SECTION 00 91 15

ADDENDUM NUMBER 6

- 1.01 DATE: APRIL 6, 2021**
- 1.02 PROJECT: WELCOME CENTER**
- 1.03 PROJECT NUMBER: DCM NO. 2020604**
- 1.04 OWNER: ALABAMA A&M UNIVERSITY**
- 1.05 ARCHITECT: NOLA | VAN PEURSEM ARCHITECTS, PC**

SHEET NUMBER
A-7.2
OF

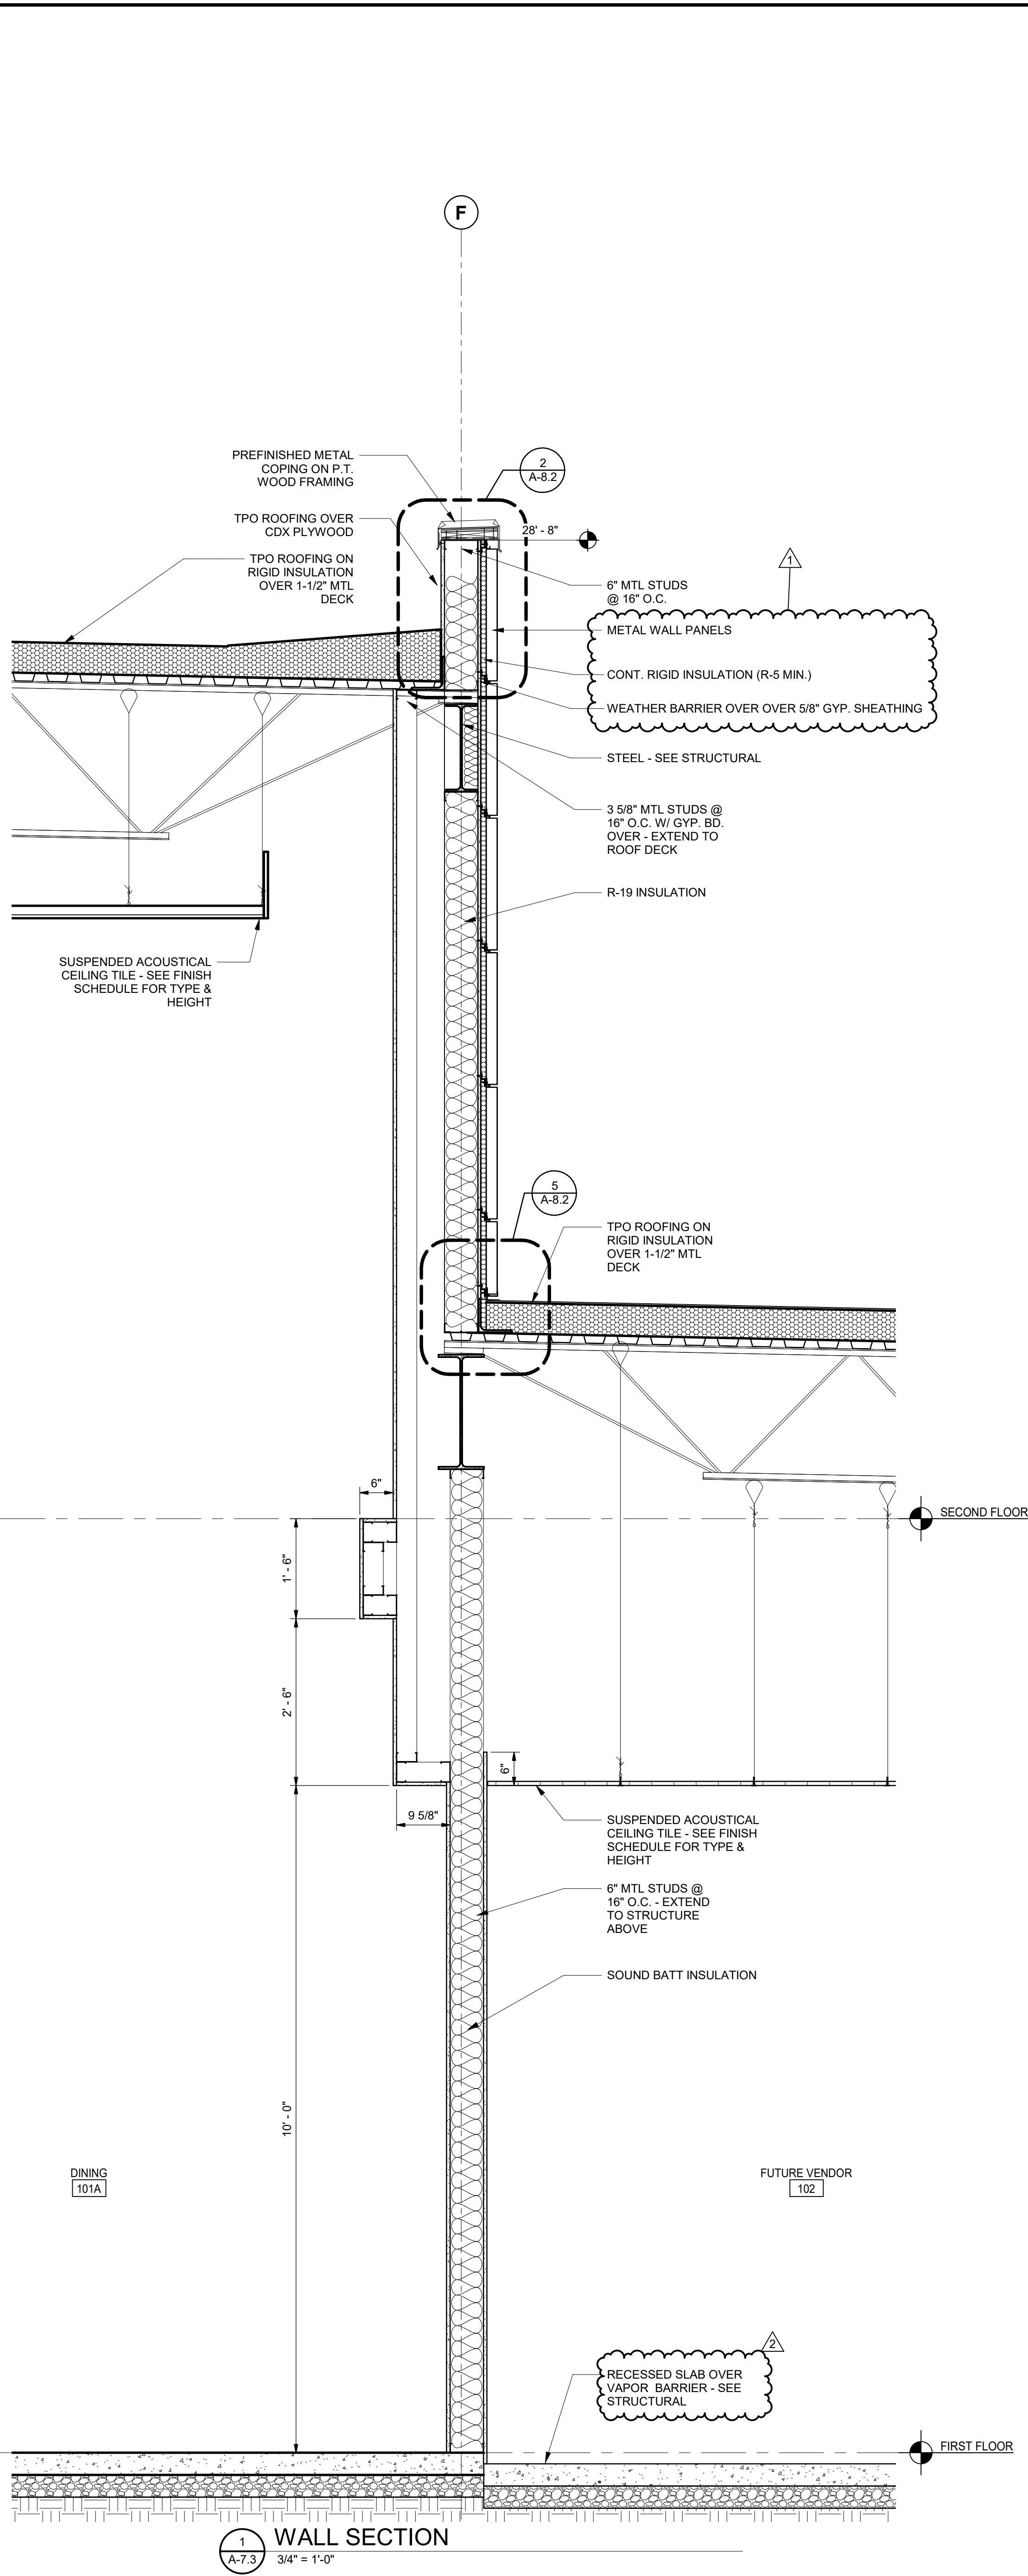
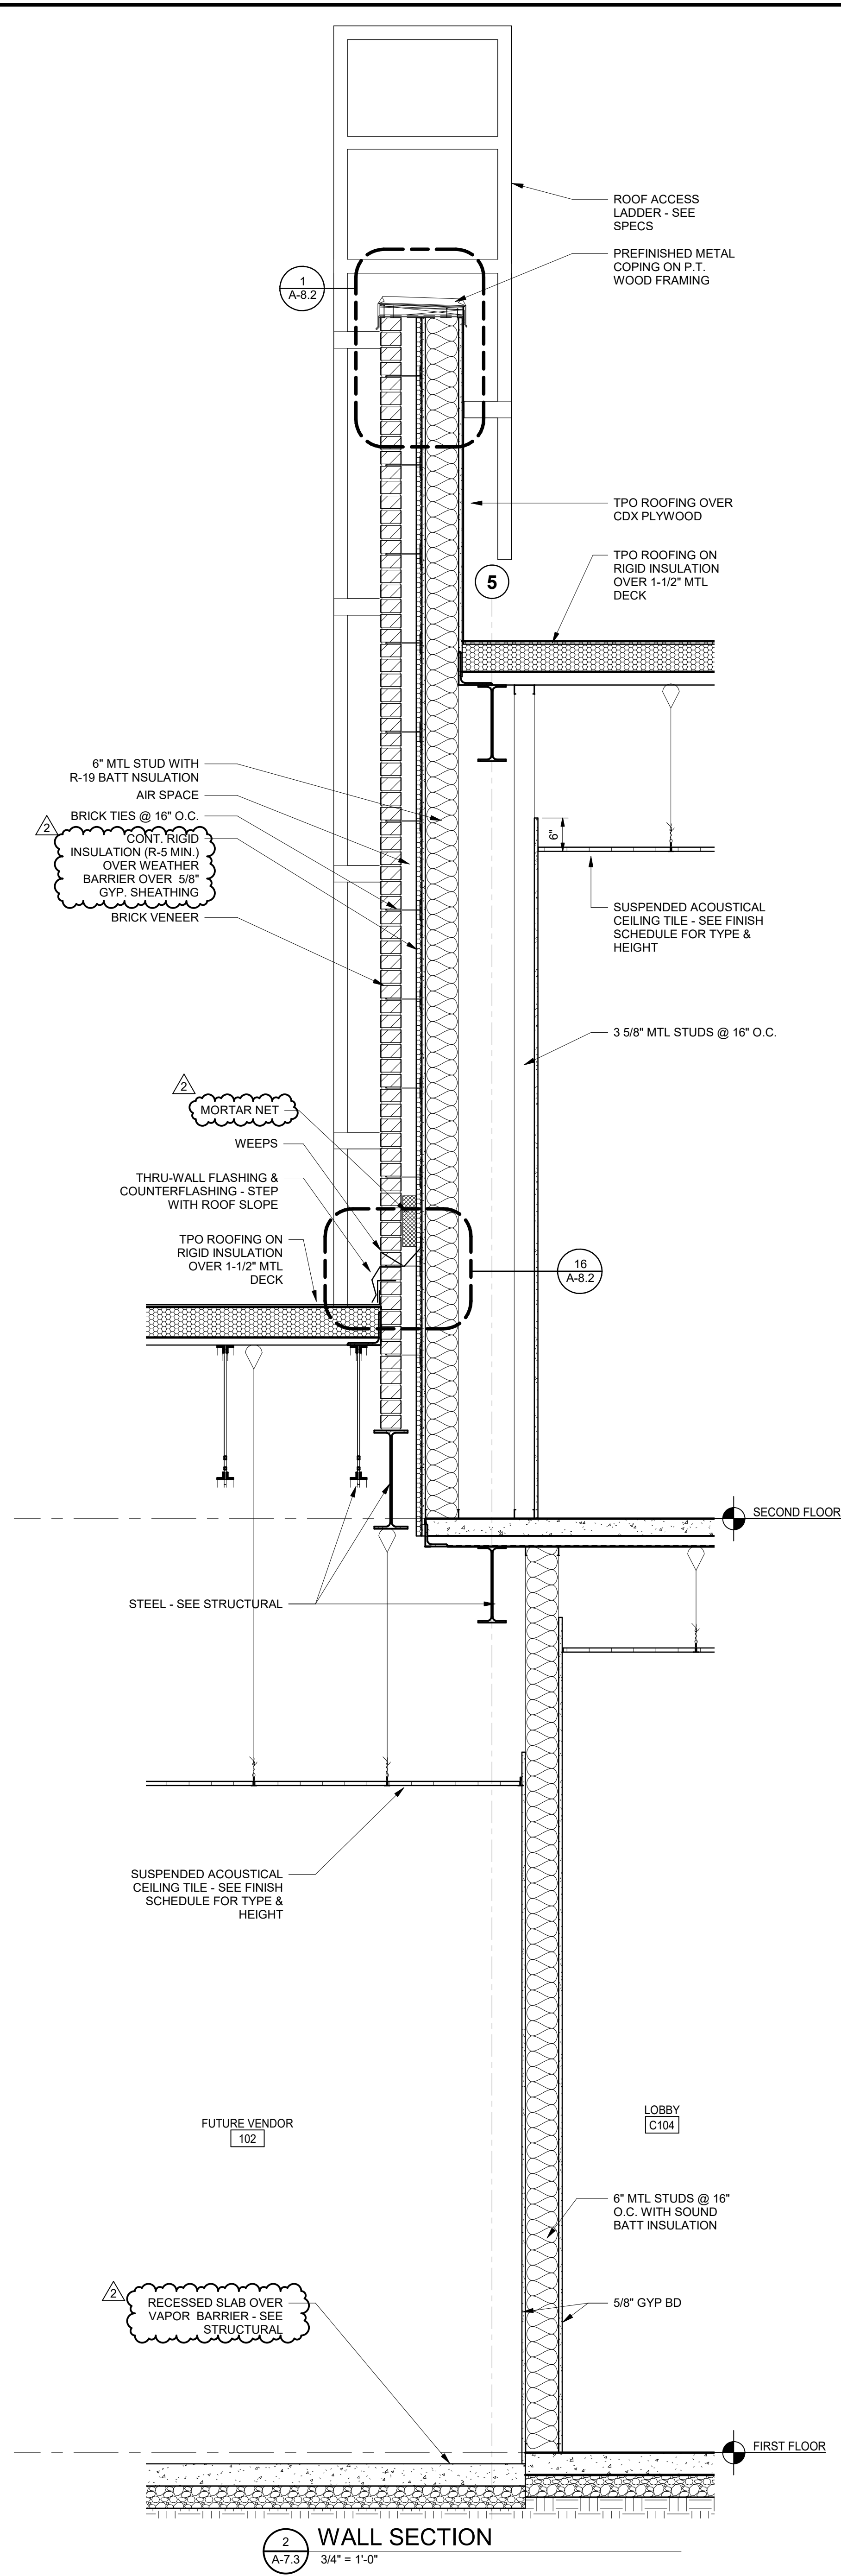
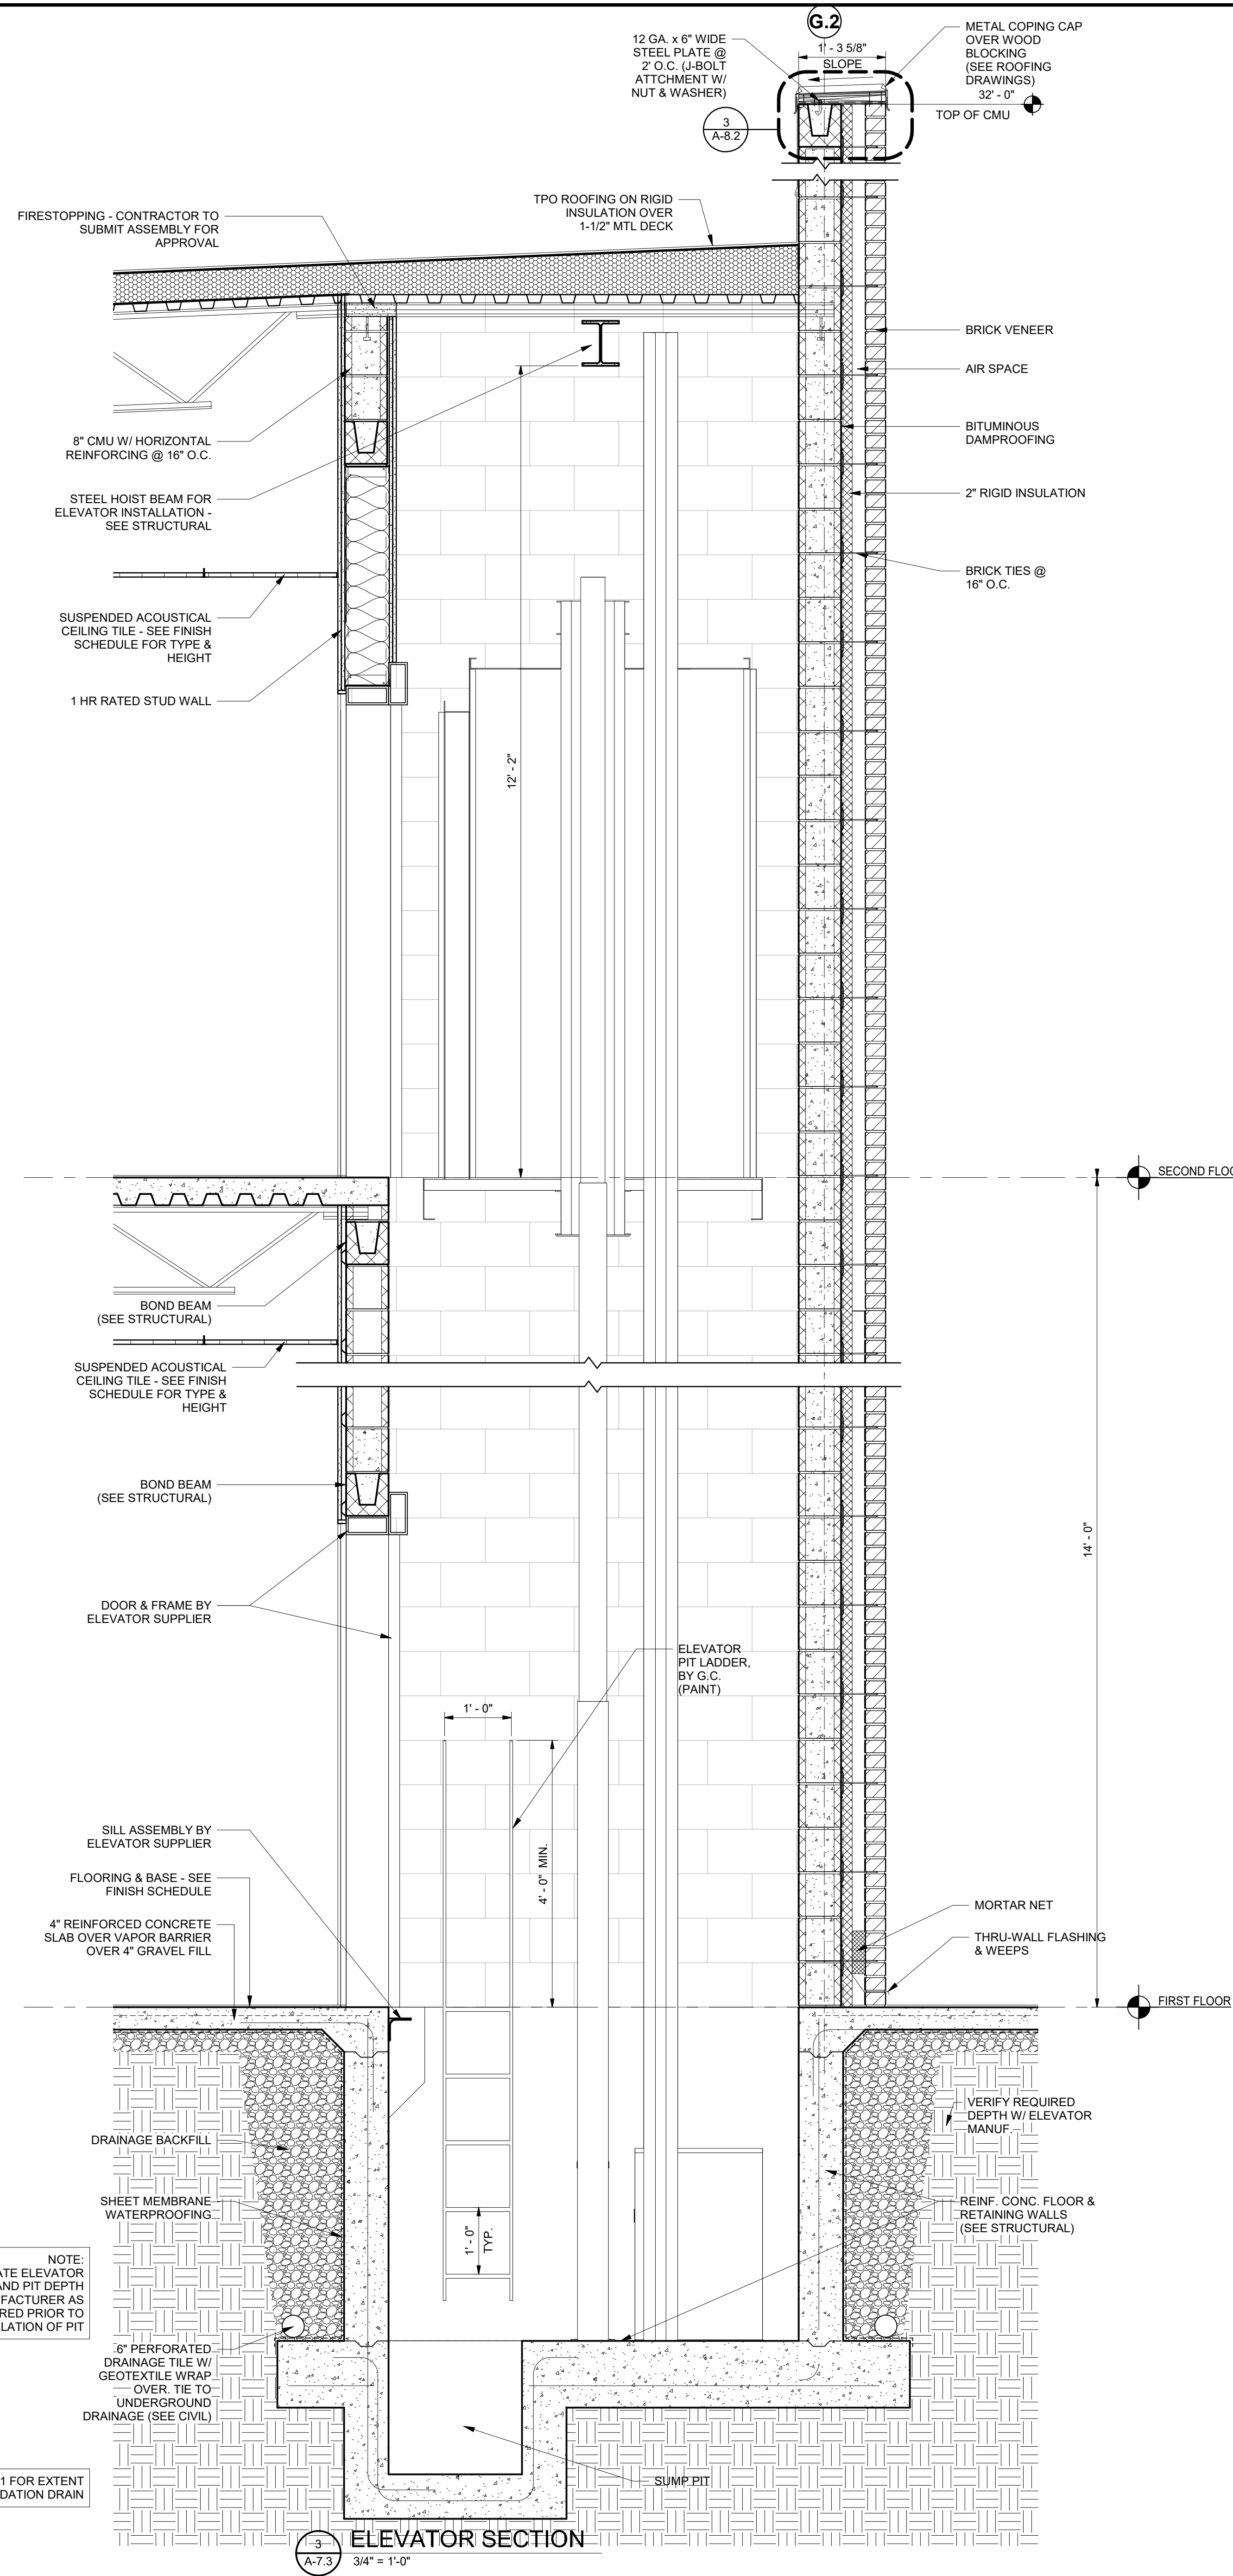
4.14 SHEET A-7.2 – WALL SECTIONS:

- A. Replace this sheet in its entirety. Revisions include the following:
1. Updated notes regarding weather barrier, EIFS.
 2. Updated exterior wall construction at second floor slab.
